Access Compliance Report

Public Rights-of-Way

(Pedestrian Signals)

Intersection ID: N/A	Main Street:	Cross Street: N/A	Location: N/A
ADA ID: 0444A7DF023B	Signal Type: One Push Button-Non APS	Overall Compliance: No	Severity Score: BTN 1: N/A BTN 2: N/A No BTN: N/A
Codes/Mitigation Info/Possible Solution		Field Measurements/Component Compliance

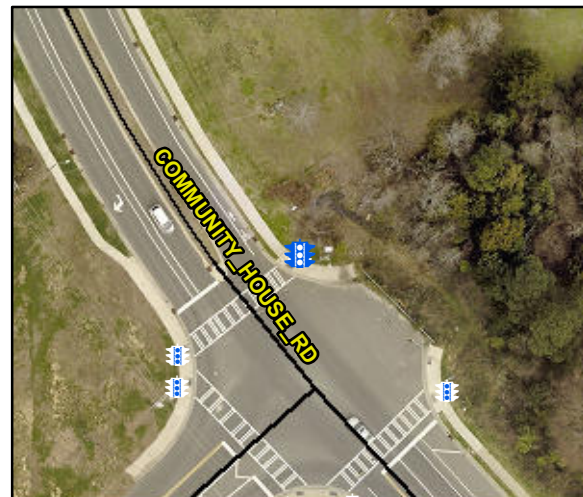
PROW/ADA: TMUTCD 4e.08, R404.7.3

Possible Solutions: Replace Signal Push Button With APS Button on New Post. Remove & Relocate Sign.
